ELV-01956  
0515

VOGTLE ELECTRIC GENERATING PLANT  
SETTLEMENT MONITORING PROGRAM ADDITIONAL INFORMATION

ALVIN W. VOGTLE NUCLEAR PLANT  
DESIGN MANUAL CHANGE NOTICE (DMCN)

DMCN NO. DC-1000C-14

FIGURE 13. ESTIMATED SETTLEMENT OF POWER BLOCK STRUCTURES

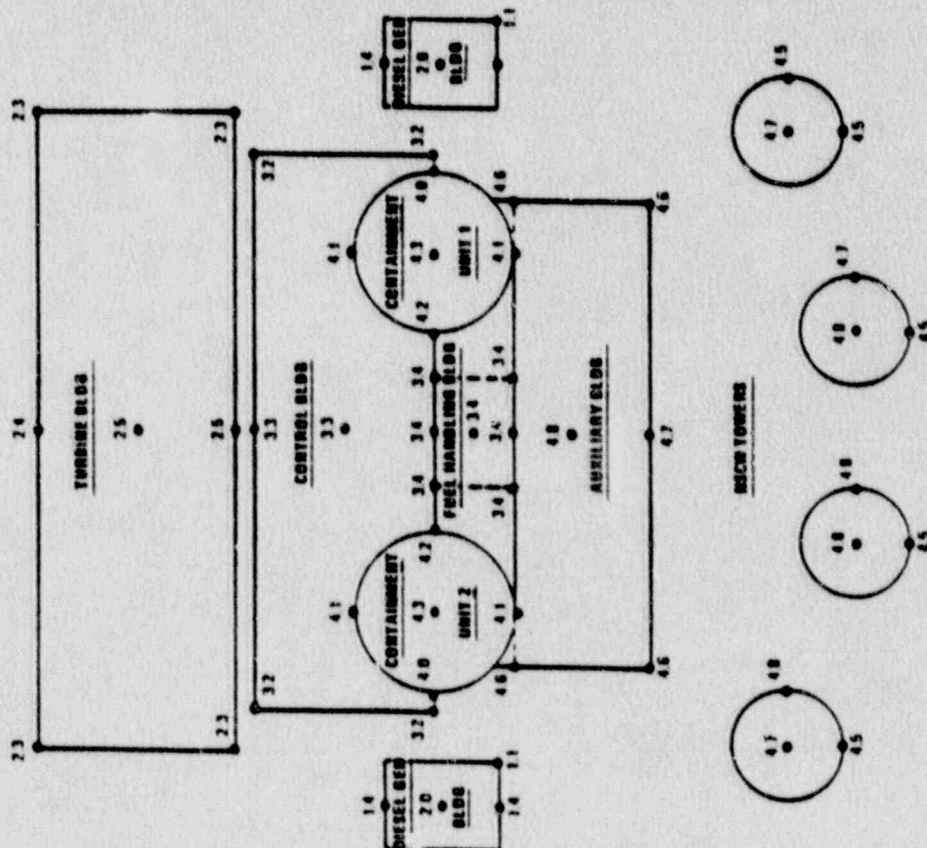
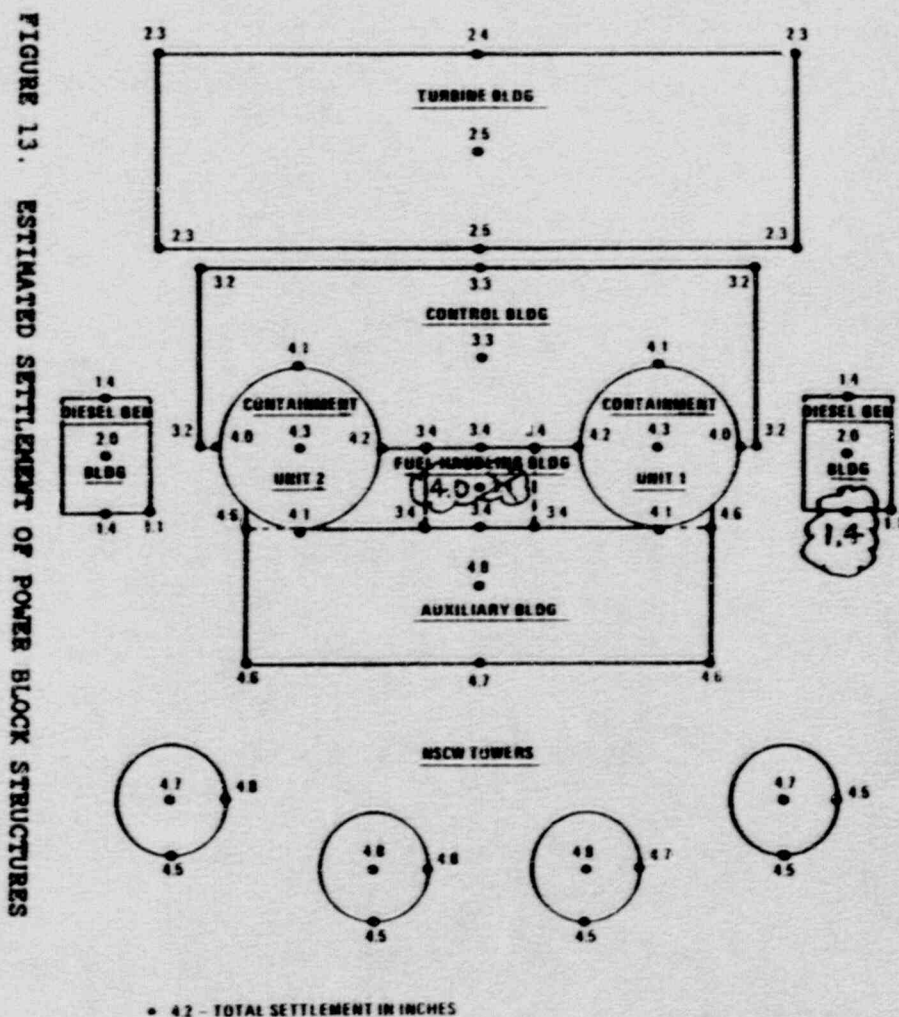
REASON FOR CHANGE To incorporate the final settlement estimates  
as determined by Project design calc. no. X2CF-S-106, rev. 1.

DESCRIPTION OF CHANGE Revision to Figure 13. "Estimated Settlement  
of Power Block Structures", p. 65, to show the latest  
settlement estimate for the center point of the Fuel Handling  
Bldg. (changed from 3.4 to 4.0). Figure 13. also revised to  
show the estimated settlement for the center of the south end  
of the Unit 1 Diesel Gen. Bldg. (1.4) that was previously  
not shown.

This figure is included in design manual change notice (DMCN) number DC-1000C-14, which was initiated to reconcile this figure with other VEGP design documents.
